Meeting Date: June 21, 2022

Hearing Body: Planning and Zoning Commission

Project Summary: **Zone Change to permit construction of a parking lot and conversion of existing single-family house into multi-family units for employee housing and an office**

PZ21-00016 (ZC) Planning Comments

SITE PLAN
 SCALE: 1"=10'-0" NORTH

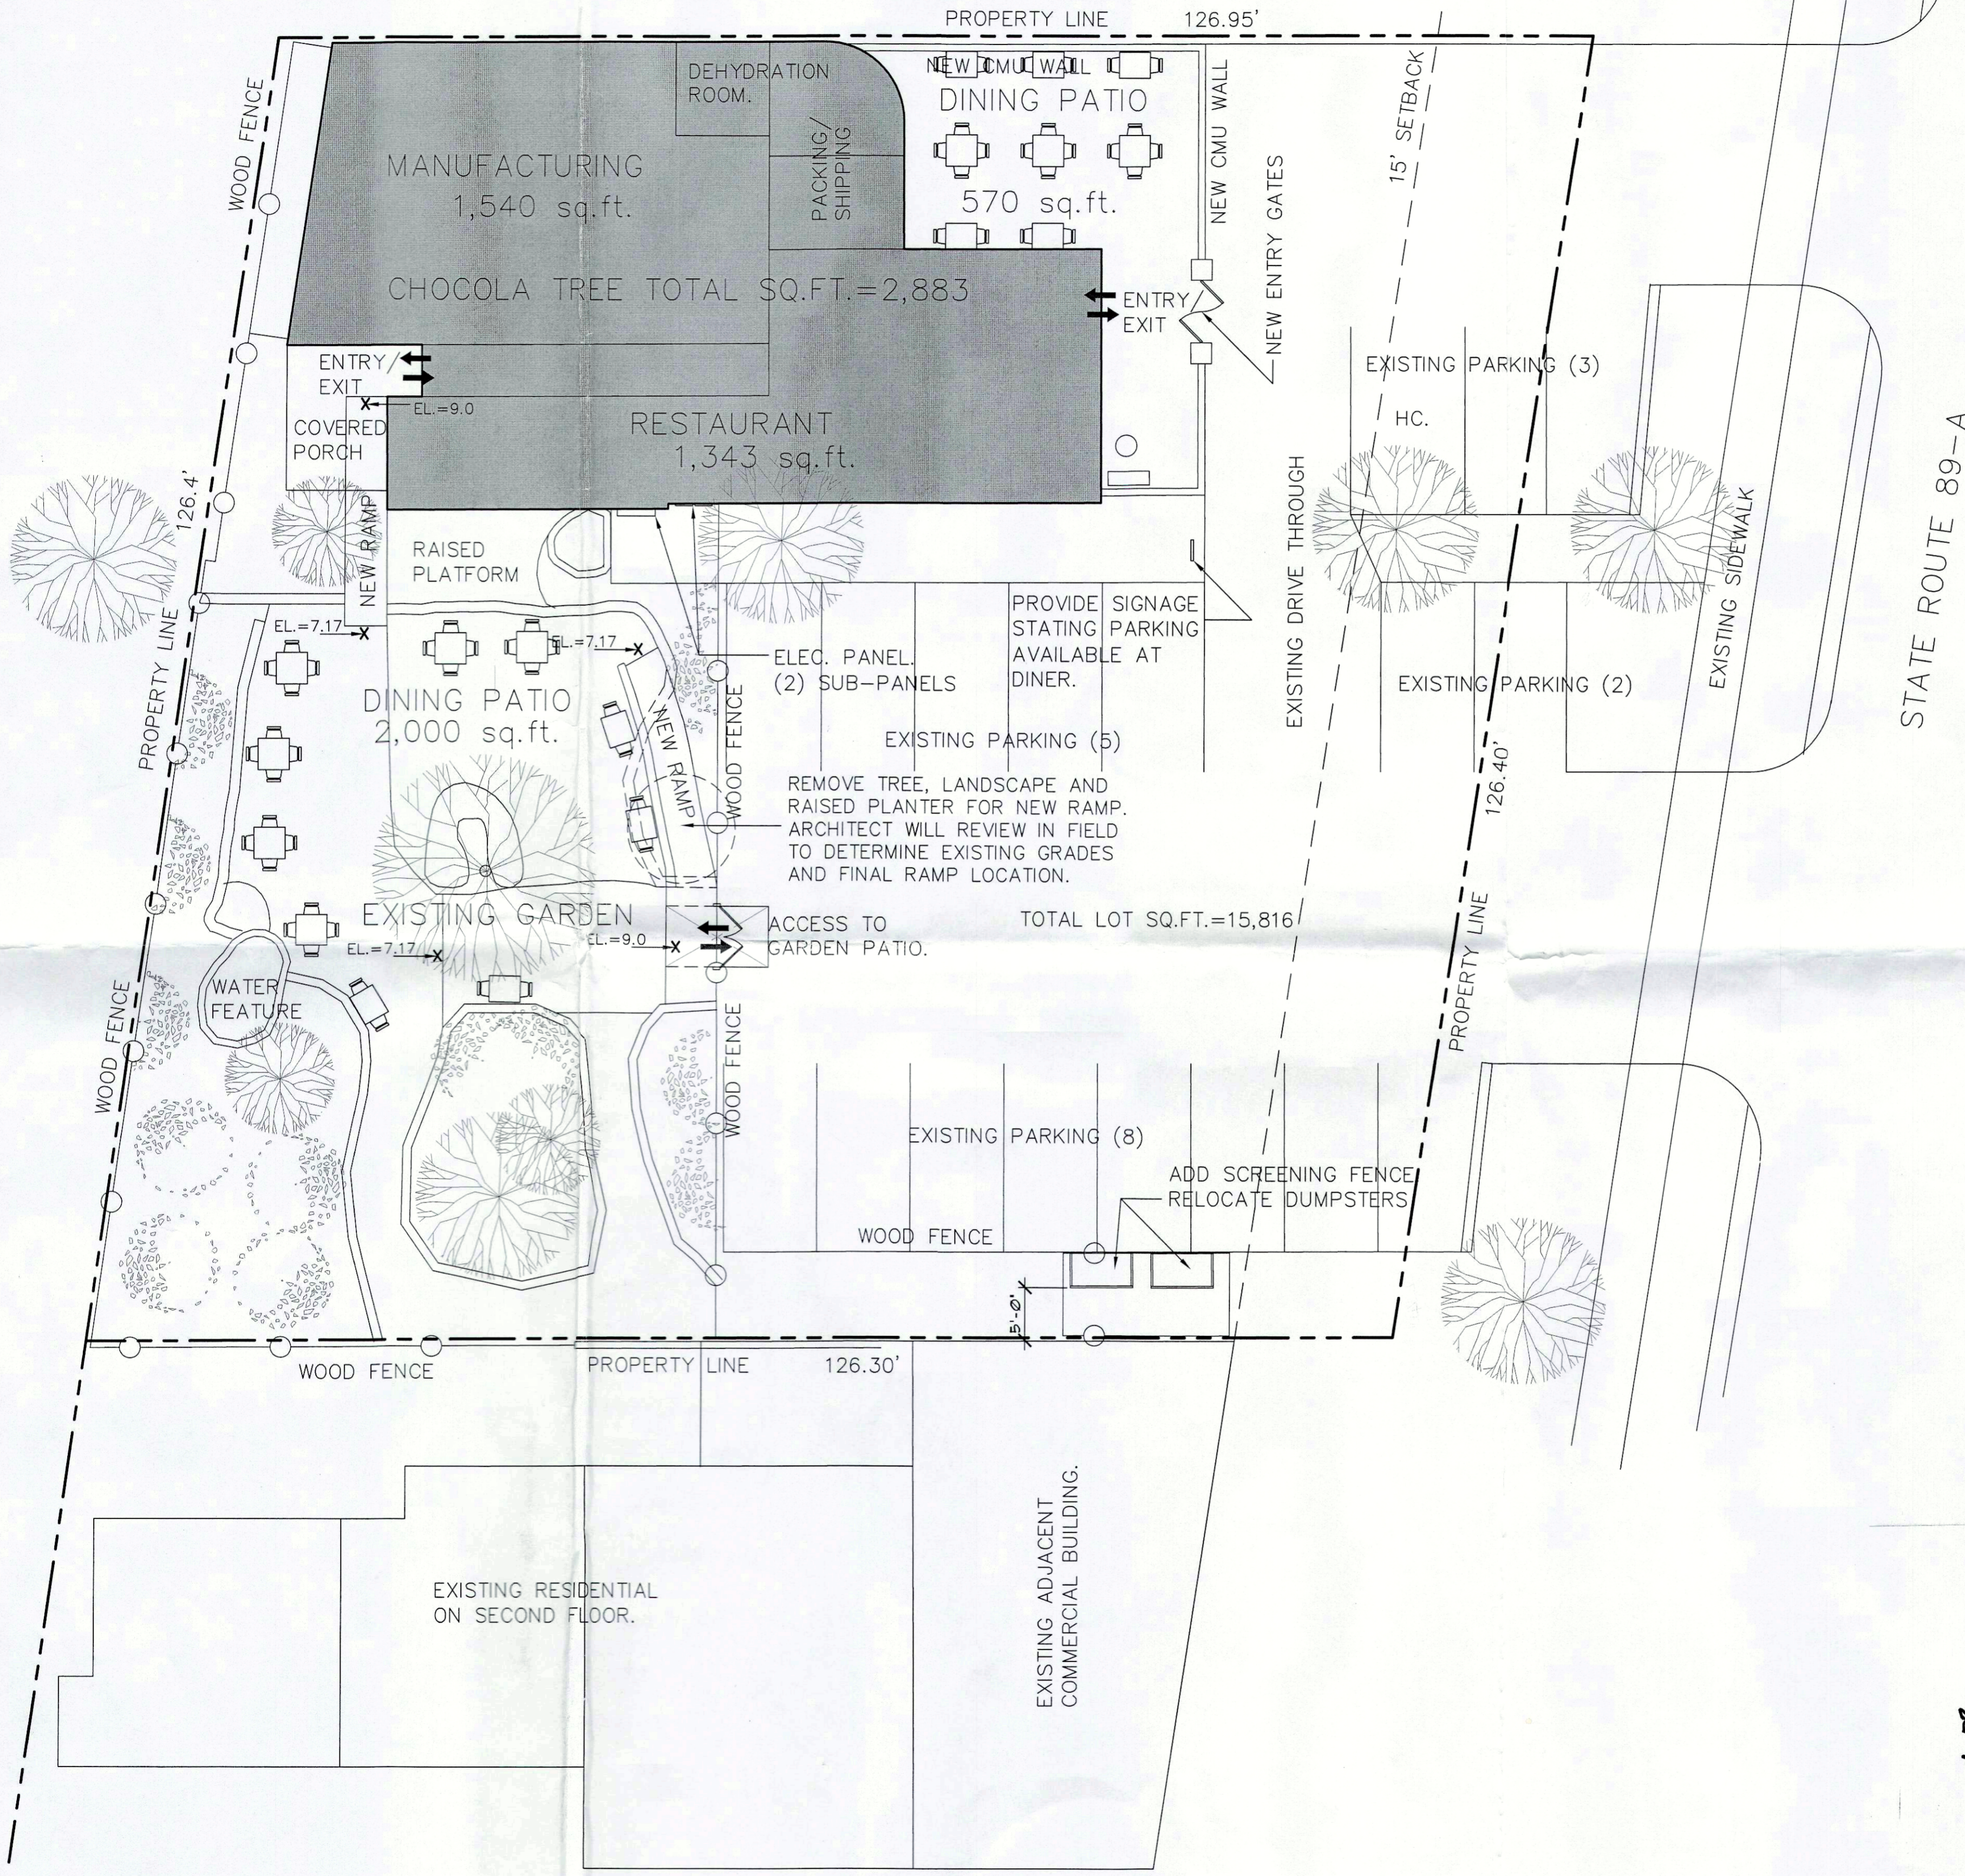
4. Letter of Intent (LOI)
 - a) Provide parking calculations for Chocolatree. Indicate whether the proposed parking will be used to accommodate existing demand or to allow for expansion of the restaurant.

- i) Parking requirements are in LDC Section 5.5. Please contact City staff with any questions regarding how parking is calculated.
5. Proposed Parking Lot

1. noted
2. noted
3. noted
4. Letter of Intent - Addendum
 - a) The proposed parking will accommodate existing demand and provide extra in the case that we are to extend seating either indoors or out. – Please reference document attached named “4a current chocolatree parking calculations”.

3. Compact spaces must be signed and mounted 5' above grade. See "11a.b.c. Preliminary Parking Signage Plan."
4. The new ADA space to be at existing ChocolaTree parking lot adjacent to existing ADA space shown on drawing "4a current chocolatree parking calculations"

1 Proposed 20 View Dr Plan
SCALE: 1/8" = 1'-0"

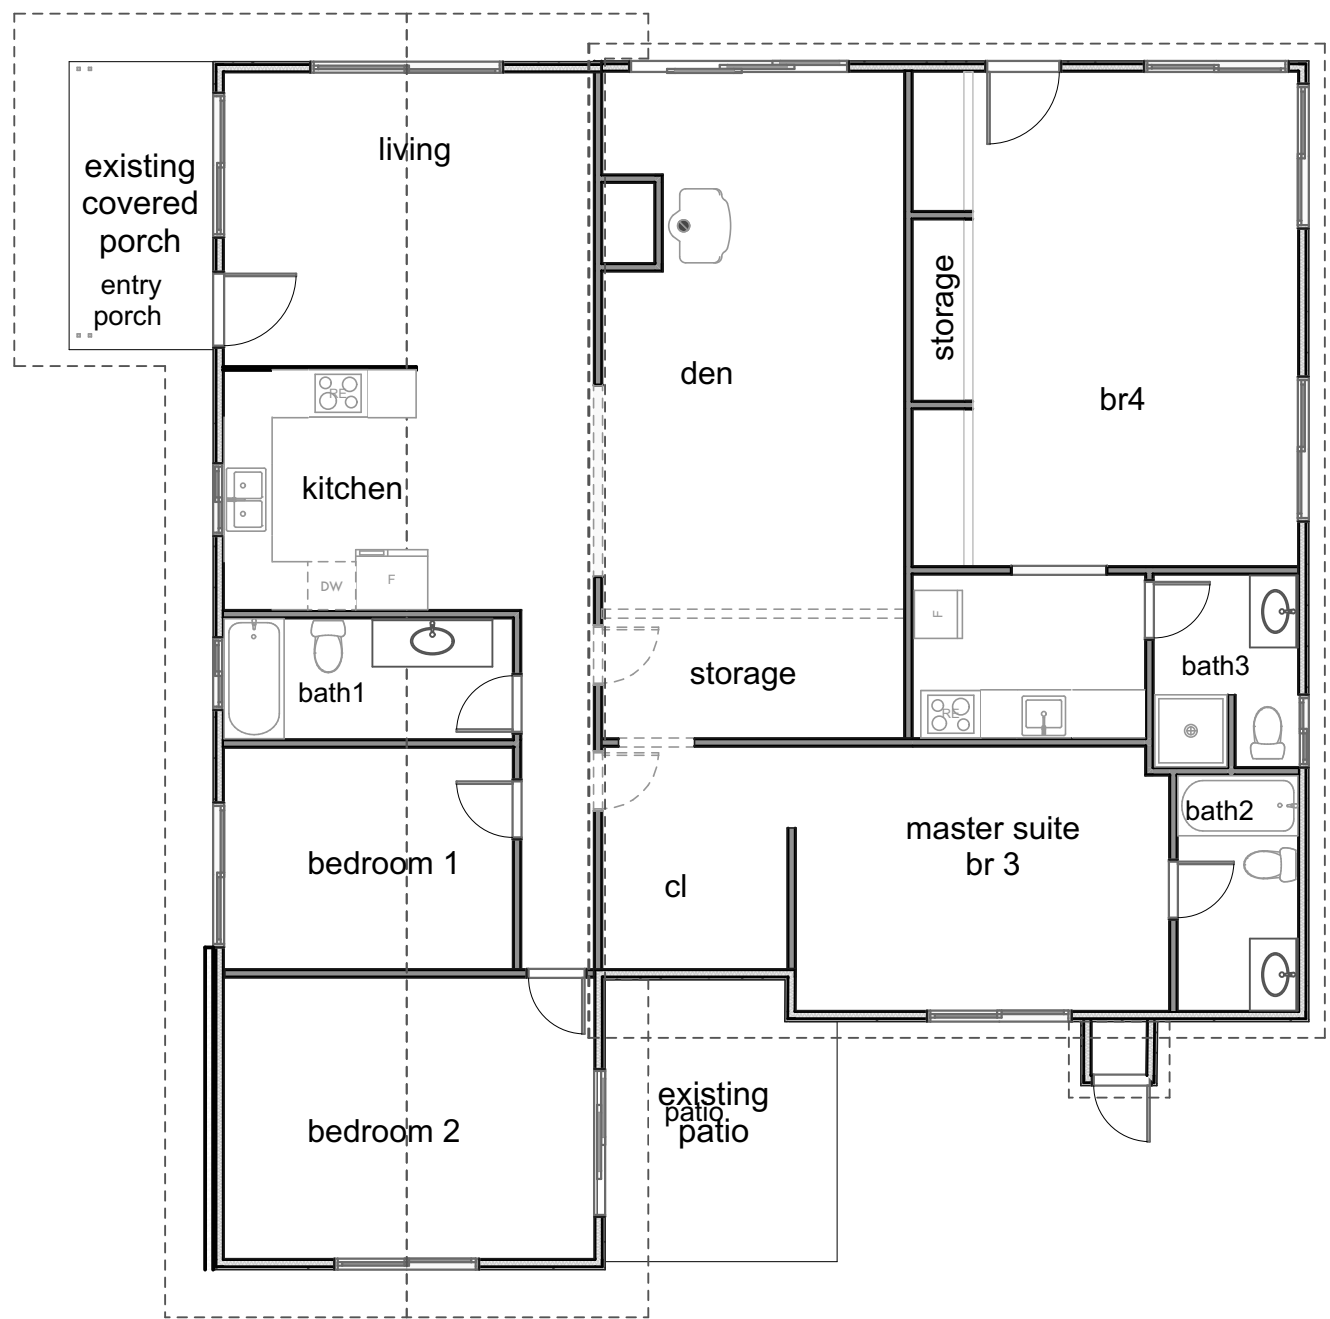
7. House on View Drive – Proposed to be converted to “M3 compliant residence and office”
 - a) Provide an explanation of how the house will be converted to become “M3 compliant”.

- b) Provide a timeline for this conversion – the LOI only states the conversion will begin within 1 year; provide anticipated completion date.
 - c) Provide a detailed floor plan of the house and a summary of the work needed for the conversion.

7. House on View Drive – Proposed to be converted to “M3 compliant residence and office”
- a. explanation of how the house will be converted to become “M3 compliant is shown in “7a. A-1 Existing 20 View Drive House Plan and Elevations.pdf” and document “7a. A-2 Demo and Proposed 20 View Plans.pdf” .Will consult with Building, Fire and Public Works officials and an architect to determine modifications necessary to convert 20 View from residential to M3 multifamily / commercial uses.

- c. Detailed floor plan of the house is addressed in 7a. Summary of the work needed for the conversion in “7c summary of work.”
 - d. noted.
8. Site Plan
